Subject: **BLACK NOISE OR WHITE NOISE AT D1
 SIGNAL RECEPTION**

Model: **BKM-20D, BKM -21D**

Serial No: **2,000,000–2, 001,730 (BKM-20D)**
2,000,000–2, 004,709 (BKM-21D)

Figure 1

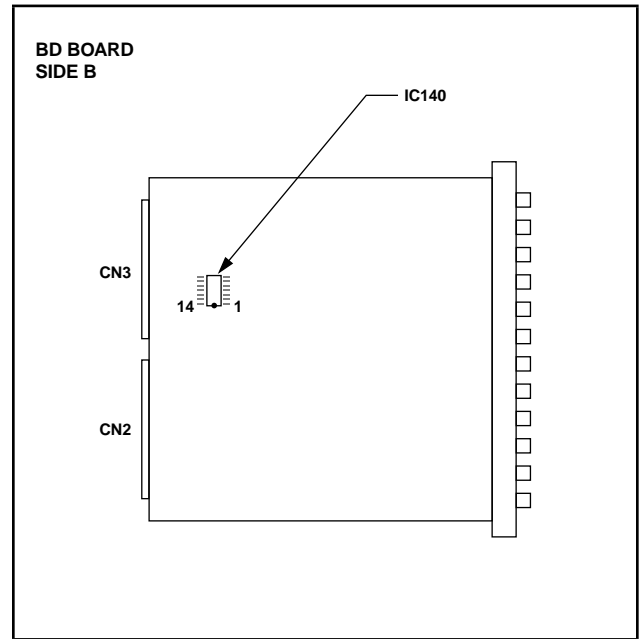
Occasionally, black noise, white noise or speck noise may appear when receiving a D1 signal in a high temperature environment. To correct this, perform the following modification.

1. Remove PCB Shield Assembly from the BD board.
2. Replace IC140 with TC74VHC125F at zone B-2 on the board.
3. No adjustment is necessary (see Figure 1).
